G.W. TATRO CONSTRUCTION, INC.
VT/AOT BRIDGE REPLACEMENT - ROAD IMPROVEMENT
RICHFORD, VT.

SHOP DRAWING C2
C22312-C2

Quantity: 2 Project No: BRFO30229 SHEET 2 OF 14

REINFORCING DETAIL
Scale: N.T.S.

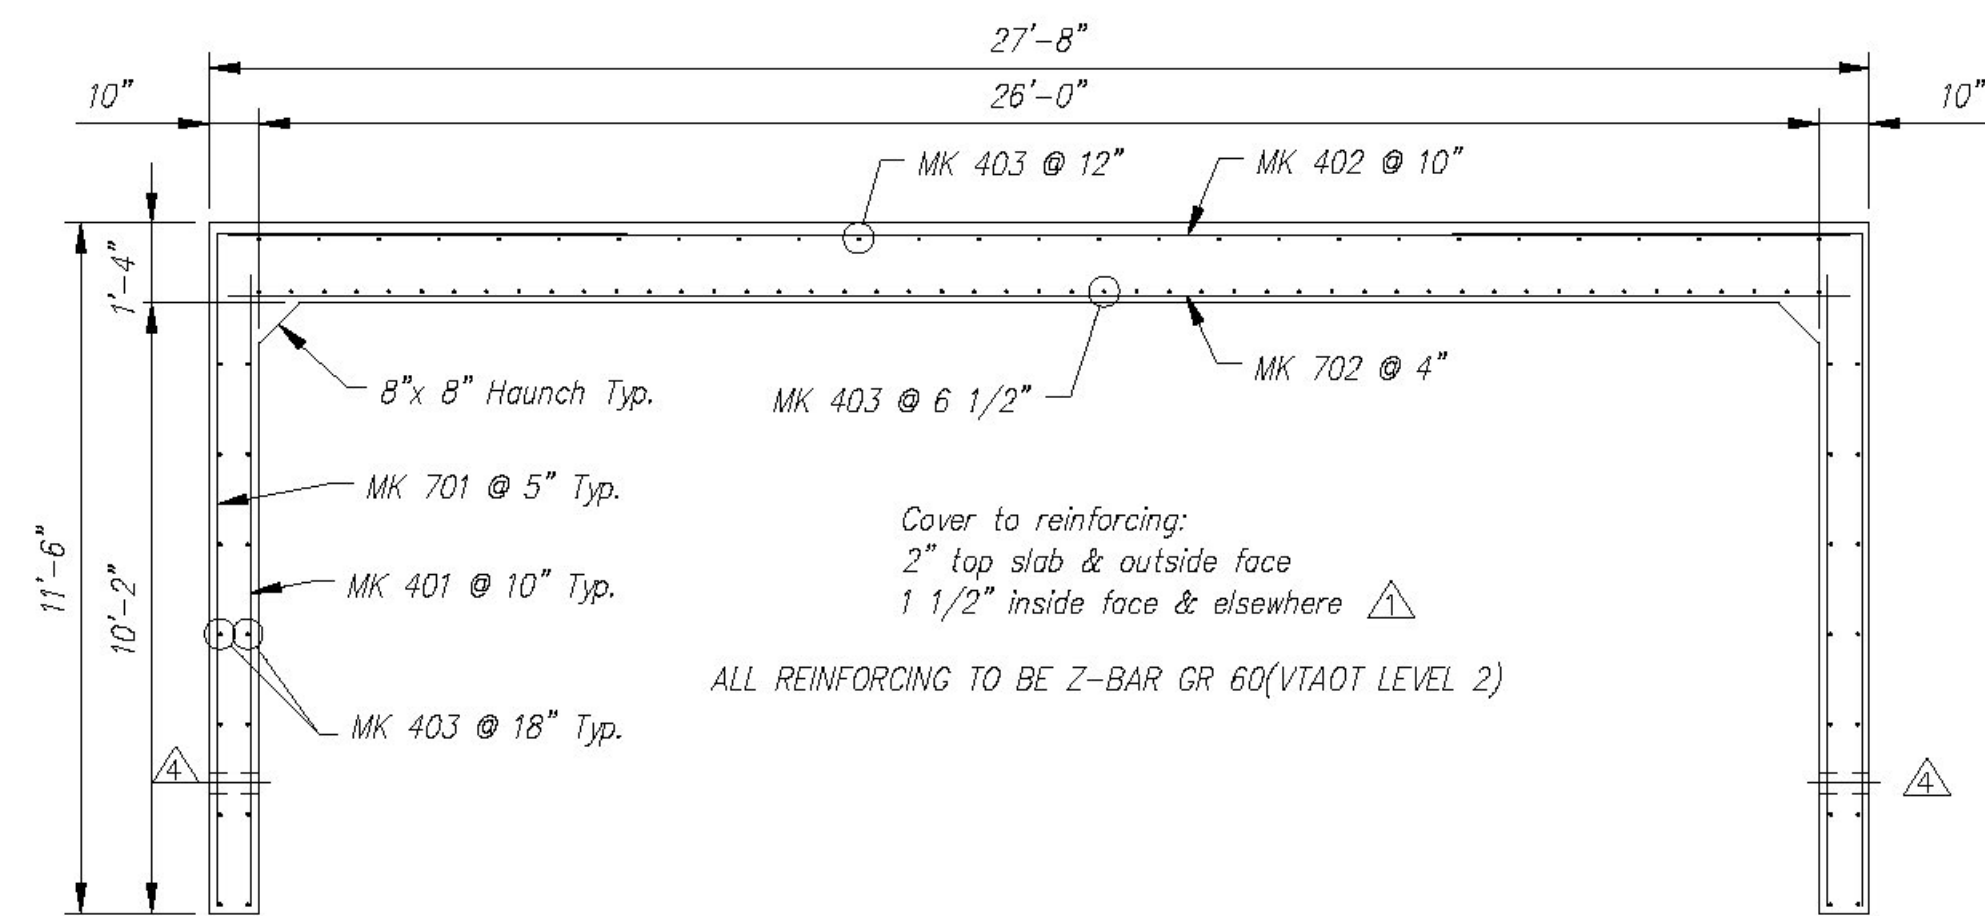
△ Culvert piece length is 1/2" shorter on shop drawing than on layout drawing.
Layout dimension includes joint gap.
